**Proposed Plan**  
**Allied Paper Landfill**  
**Allied Paper/Portage Creek/Kalamazoo River Superfund Site – Operable Unit 1**

**DRAFT - July 2015**

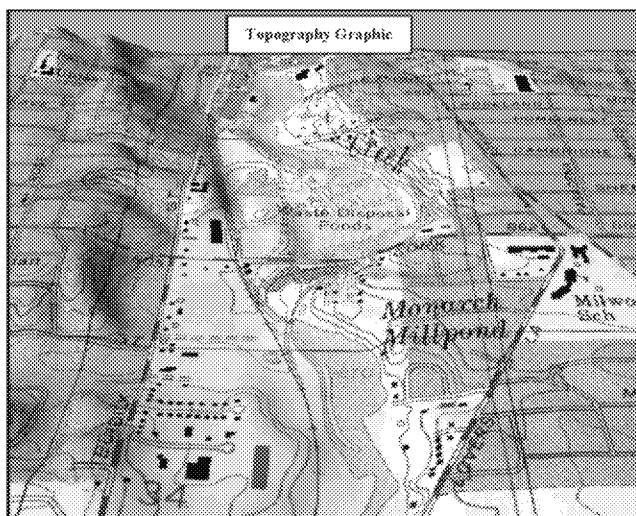
**Commented [RLF2]:** The figure below needs a north arrow...
